# Access Compliance Report

## Public Rights-of-Way (Curb Ramps)

Intersection ID: N/A	Main Street: INDEPENDENCE_RD	Cross Street: N/A	Location: N
ADA ID: 834522BB66E4	Ramp Type: PerpDiag	Initial Pass/Fail: Fail	Overall Compliance: No Severity Score: 37.5

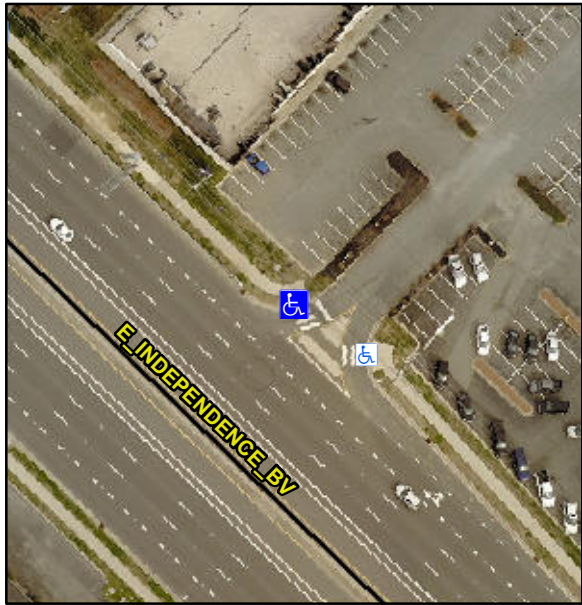
Codes/Mitigation Info/Possible Solution		Field Measurements/Component Compliance						
	Possible Solutions:		Compliance	Description	Data	Compliance	Description	Data
	<b>Remove &amp; Replace Curb Ramp With Two New Directional Ramps or Equivalent.</b>		N/A	Ramp Length (in)	72.0	No	Ramp Slope (%)	11.5
			Yes	Ramp Width (in)	48.0	No	Ramp XSlope (%)	9.9
			N/A	Flare Type LT	N/A	N/A	Flare Type RT	N/A
			N/A	Flare Slope LT (%)	N/A	N/A	Flare Slope RT (%)	N/A
			N/A	Flare Traversable LT?	N/A	N/A	Flare Traversable RT?	N/A
			N/A	Landing Length (in)	N/A	N/A	DWS Provided?	N/A
			N/A	Landing Width (in)	N/A	N/A	DWS Contrast?	N/A
			N/A	Landing Slope (%)	N/A	N/A	DWS Length (in)	N/A
			N/A	Landing X Slope (%)	N/A	N/A	DWS Full Width?	N/A
Surveyor Notes:		N/A	Landing Curb? (Y/N)	N/A	N/A	DWS Offset (in)	N/A	
PROW/ADA:		N/A	Shared Landing?	N/A				
<b>R304.2.2, R304.5.3</b>		N/A	Gutter Ponding?	N/A	N/A	Gutter Slope (%)	N/A

N/A	Gutter Lip Ht (in)	N/A	N/A	Gutter X Slope (%)	N/A	
		N/A	Painted X Walk1?	No	N/A	Painted X Walk2?	Yes	
			X Walk 1 Direction	To SW		X Walk 2 Direction	To SE	
		N/A	X Walk 1 Width (in)	N/A	N/A	X Walk 2 Width (in)	119.0	
			X Walk 1 Slope (%)	10.2		X Walk 2 Slope (%)	5.8	
			X Walk 1 X Slope (%)	4.5		X Walk 2 X Slope (%)	10.1	
		N/A	Ramp inside XWalk1?	N/A	N/A	Ramp inside XWalk2?	Yes	
			Road Slope (%)	9.6	N/A	Clear Space?	N/A	
			Road X Slope (%)	8.4	N/A	Clear Space to XWalk (in)	N/A	
Total Cost:		\$	3200.00	N/A	N/A	Storm Grate/Utility Hazard?	N/A	
						Storm Grate/Utility Type		
				N/A			N/A	
					Yes	Surface Condition? (G/P)	Good
